**Subject: Draft Corrective Action Plan for Groundwater, Maryland Square Shopping Center**

**Facility:** Al Phillips the Cleaner (former)  
3661 S. Maryland Parkway  
Las Vegas, NV

**Facility ID: H-000086**

**ATTACHMENT 1 – SPECIFIC COMMENTS**  
**Draft Corrective Action Plan for Groundwater, Maryland Square Shopping Center,**  
**Facility ID: H-000086**

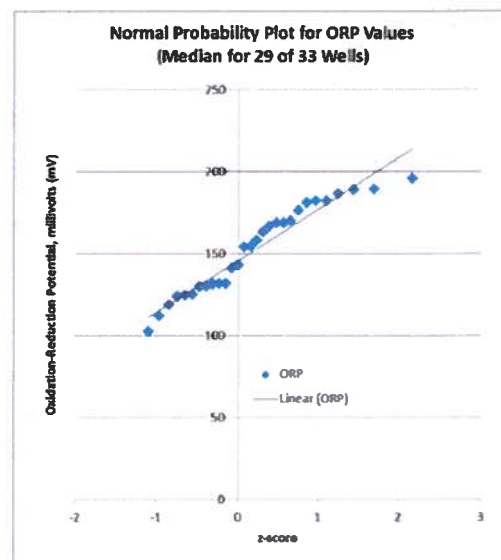
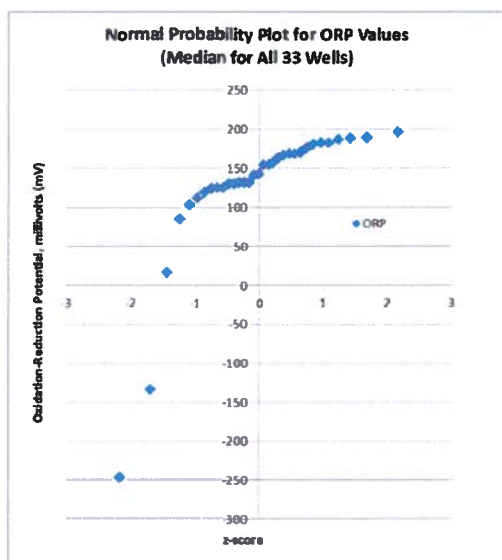
39. Page 11, fourth paragraph states that *"The plume at the Site is assumed to be stable at its eastern extent."*

Any such statement regarding plume stability should be tested, not assumed. Please apply a statistical trend test to evaluate stability at confidence levels of 80% and 90%.
